RESPONSE TO REQUEST FOR ADDITIONAL INFORMATION

APR1400 Design Certification

RAI No.: 154-8064
SRP Section: 16 - Technical Specification
Application Section: 16 - Technical Specification
Date of RAI Issue: 08/17/2015

Question No. 16-45

16.1.2.4 Combined License Information

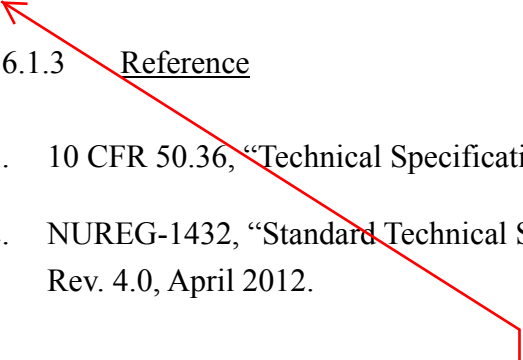
Regarding generic TS and Bases references to the APR1400 DCD, COL plant-specific TS and Bases will need to change DCD to FSAR, or add FSAR to references to the FSAR, following COL issuance by way of (1) the license amendment process, as we have seen with the Vogtle Units 3 and 4, and Summer Units 2 and 3; or (2) the generic TS exemption process, as we have seen with the South Texas Project (STP) Units 3 and 4 COL application. Staff concludes that it is more efficient to use "FSAR" instead of "DCD" in generic TS and Bases, thus avoiding having to process an exemption during the COL application review, or a license amendment after COL issuance to change DCD to FSAR. Accordingly, the applicant is requested to replace all DCD Tier 2 references in the proposed generic TS and Bases to FSAR references, and add FSAR to DCD references that do not include the modifier DCD or DCD Tier 2. Staff also suggests revising DCD Tier 2 Section 16.1.2.4 Combined License Information, with a statement to explain that in the generic TS and Bases, FSAR means DCD Tier 2.

To enable the licensing process for the Combined License (COL) application or a subsequent license amendment after a COL issuance, KHNP will replace all DCD Tier 2 references in generic Technical Specifications and Bases to FSAR references in Revision 1 of the DCD. Also, the text of DCD Tier 2 Section 16.1.2.4 Combined License Information will be revised as shown in attached markup.

DCD 16.1.2.4 will be revised as shown in attached markup.

The references in generic TS and Based include FSAR. FSAR will be available in COL step. The main reason of it is to avoid having to process an exemption during the COL application review, or a license amendment after COL issuance to change DCD to FSAR.
